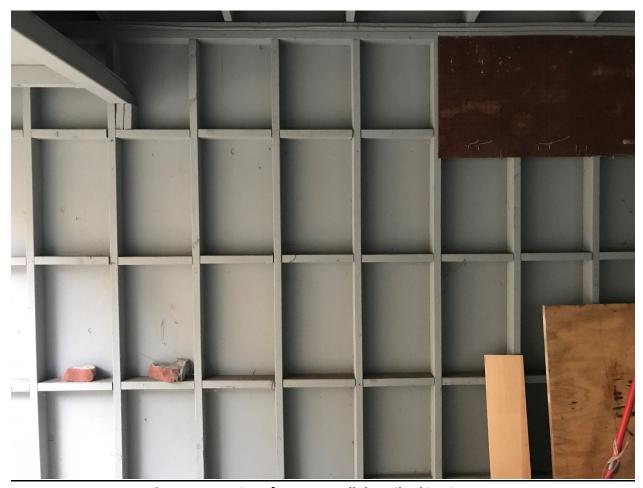
Figure 4: Non-conforming carport wall. The subject wall does not meet the composite setback requirements. The wall shall remain intact for the duration of construction, and any removal shall require the wall to be brought into a compliant location. The yellow/green string in the photo indicates the location of the 3' setback.
